RE: Drainage Report for Parcel 2A, Sunport Park (M15/D23) Submitted for Site Development Plan for Building Permit Approval, Engineer's Stamp Dated 3/6/97.

We have been requested by the Aviation Department to review and comment on the Sunport Park Drainage MasterPlan submitted to the City for review. We have reviewed sheet C-2 of the masterplan dated February 25, 1997, and offer the following comments on behalf of the Aviation Department:

DRAINAGE MASTERPLAN

DRAINAGE MASTERPLAN

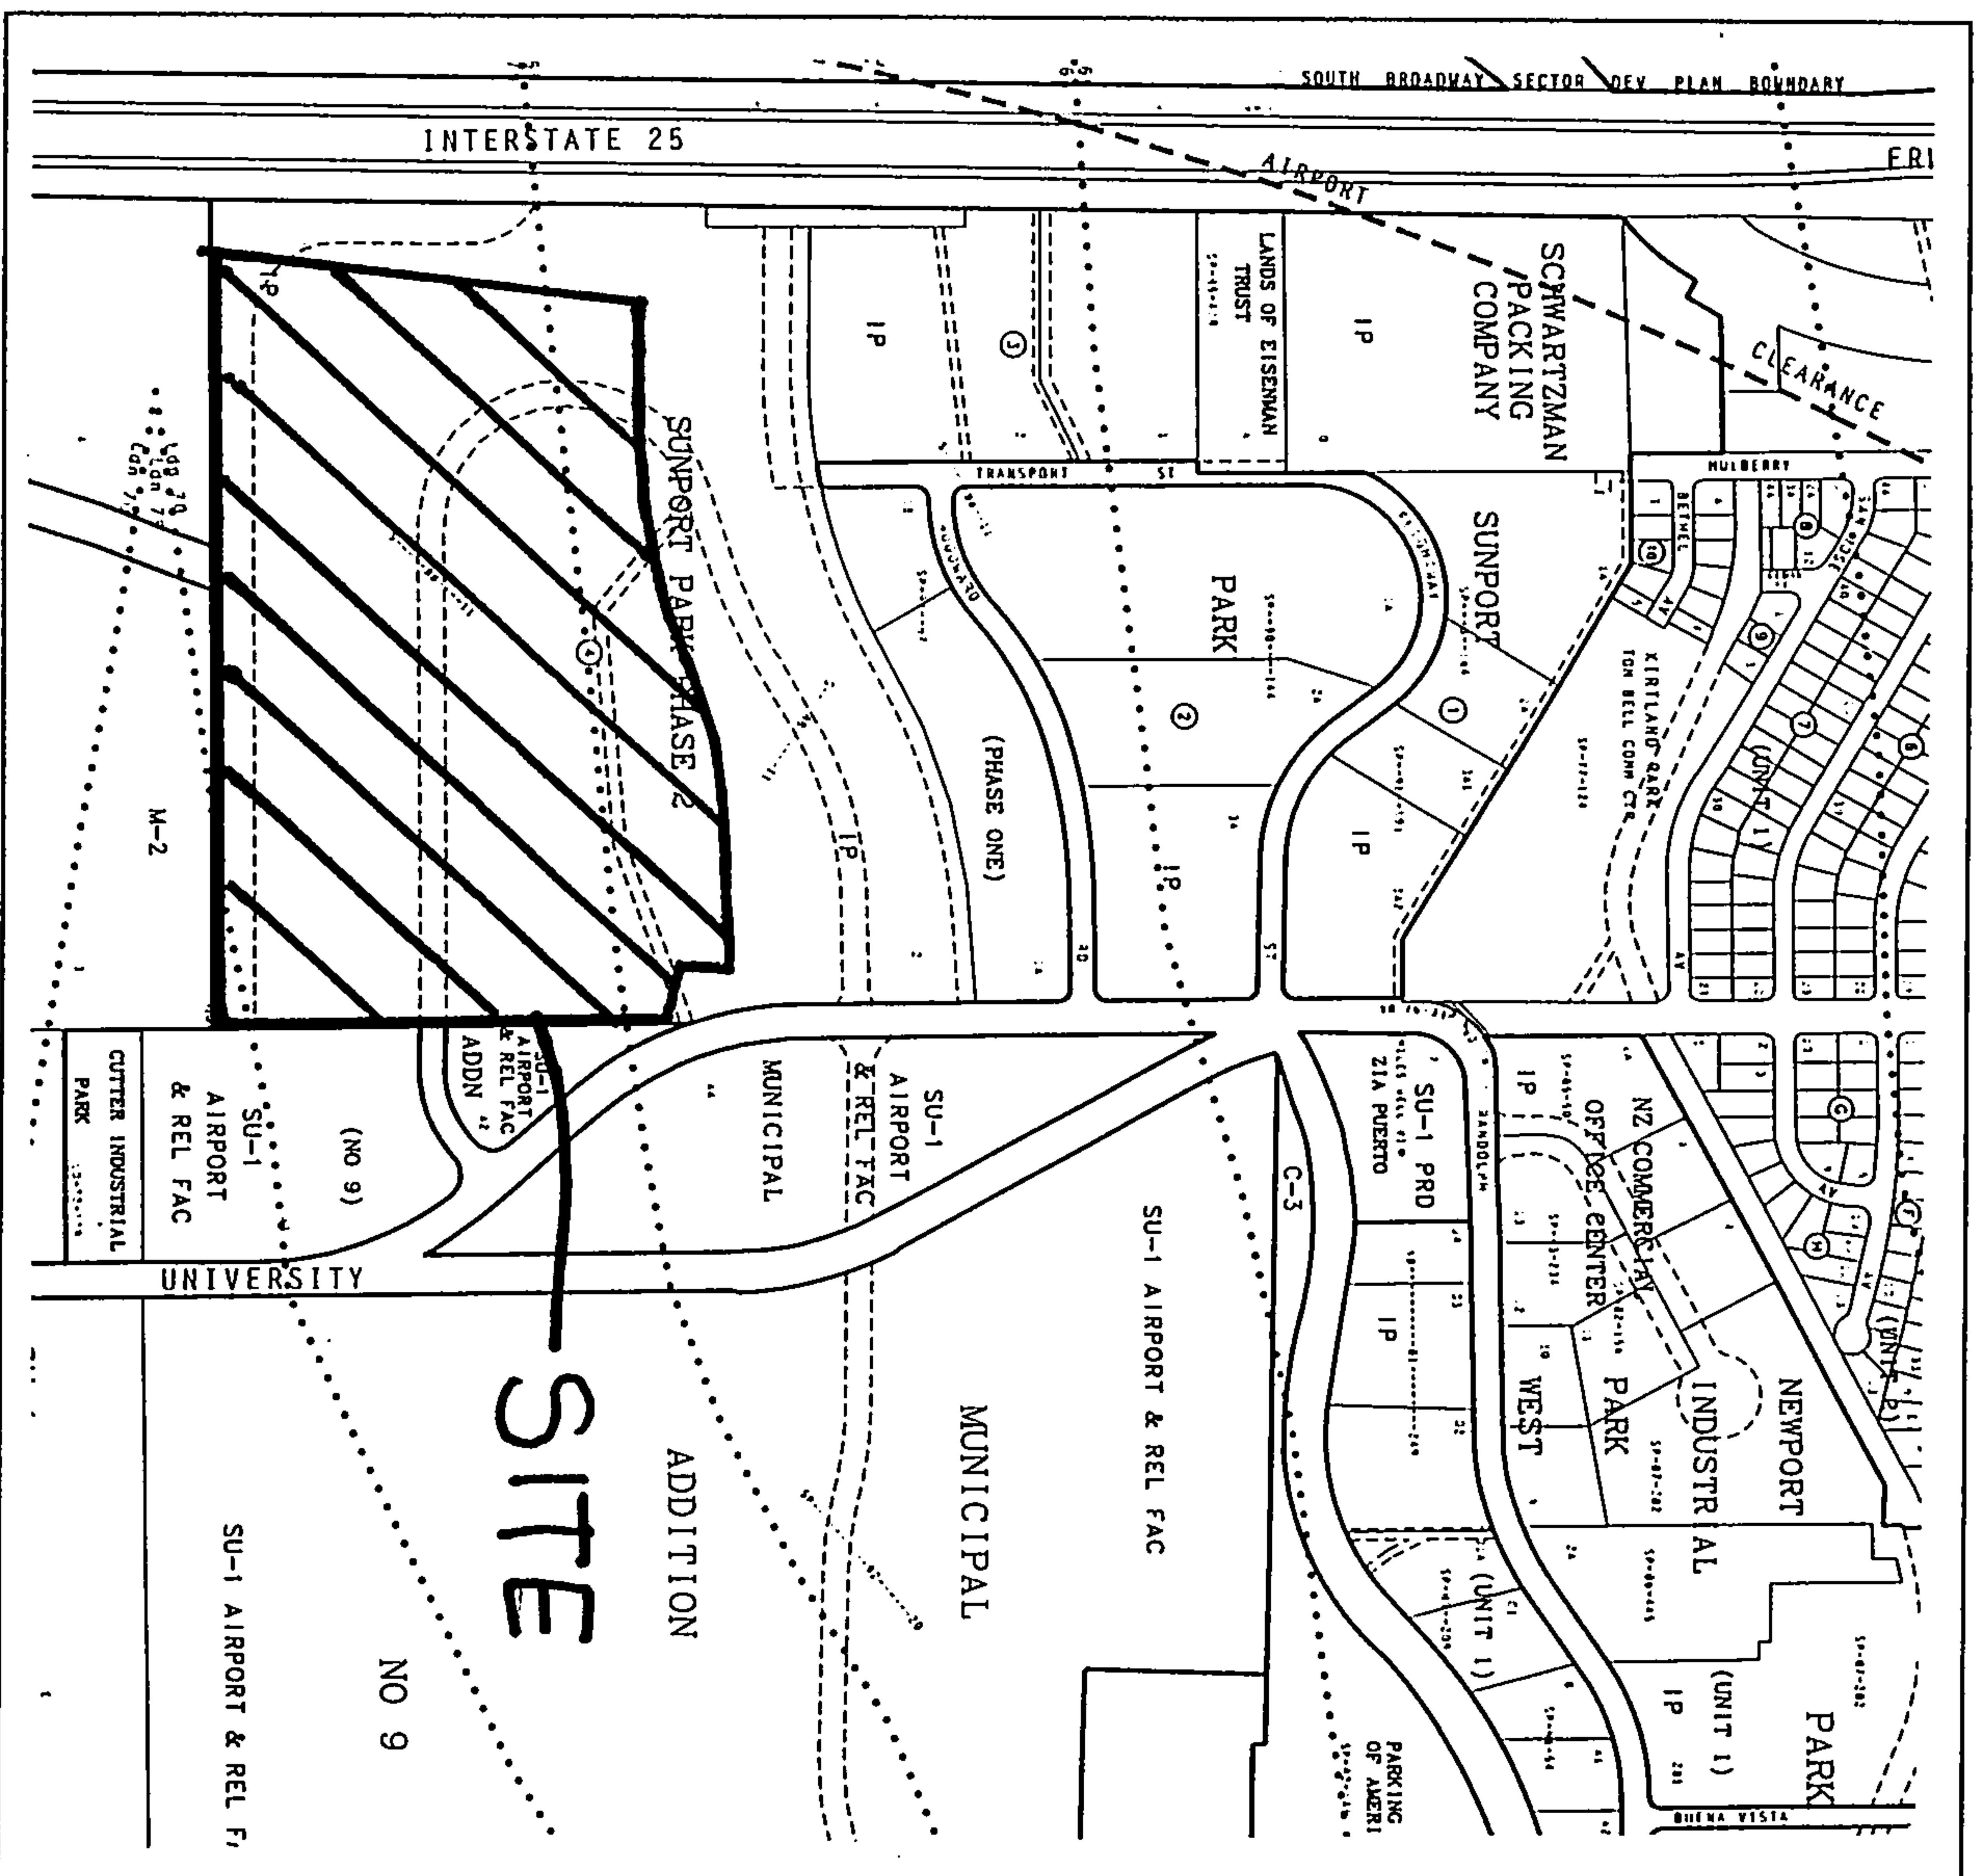
1. The drainage boundaries illustrated on the Phase I portion of the proposed development do not agree with the masterplan prepared by Andrews, Asbury and Robert (AAR). The land treatment shown indicates a 100 percent impervious surface. The Sunport system was designed to accept the basin as shown on that masterplan. The AAR masterplan indicated a land treatment consistent with commercial development with a maximum of 90 percent impervious surface. Undetained flow from the system, shown on the current drawing, may exceed the system capacity.

2. The capacity and structural integrity of the 3-36" RCP crossing at I-25 are of concern due to age and condition. Calculations performed during the preparation of the Sunport Boulevard Drainage Report indicate that the capacity of this structure is approximately 300 cfs. This capacity should not be exceeded in order to protect the improvements constructed in the Sunport Boulevard projects.

3. There is not an easement identified for the 42" outfall pipe from the detention pond.
4. A public detention pond is proposed. Who will be responsible for maintenance?

5. Drop inlets are indicated on the north boundary of Phase I. We assume these are intended to catch surface flows. The finished grading shown indicates a slope of approximately 5% with a cross slope. Will the drop inlets be effective in collecting the surface water prior to reaching the western boundary of the development with the cross slope indicated?
6. Will the proposed public detention pond require permitting through the State Engineer's Office?
7. What provisions will be made for an emergency spillway for the proposed pond?

We have received your March 28, 1997 letter via facsimile from Fred Aguirre regarding the subject project. It is my impression that your comments are based on review of sheet C-2 in the Site Development Plan submittal made by Rick Bennett, project Architect. A comprehensive Drainage Masterplan Report was submitted separately to City Hydrology, which is enclosed for your review. The DMP should contain adequate information to address your concerns. Specifically you comments are addressed as follows:

1. Per the Drainage Report for Sunport Boulevard prepared by molzen-Corbin an 18.8 acre basin contributing 85.4 cfs was planned to be intercepted by the Sunport storm drain. This project is proposing a 5.4 acre basin contributing 25.4 cfs. Capacity of the storm drain is not exceeded by this project.

7. An emergency spillway will be provided from the proposed from the north side of the detention pond. Downstream easements and conveyances will be provided per City criteria.
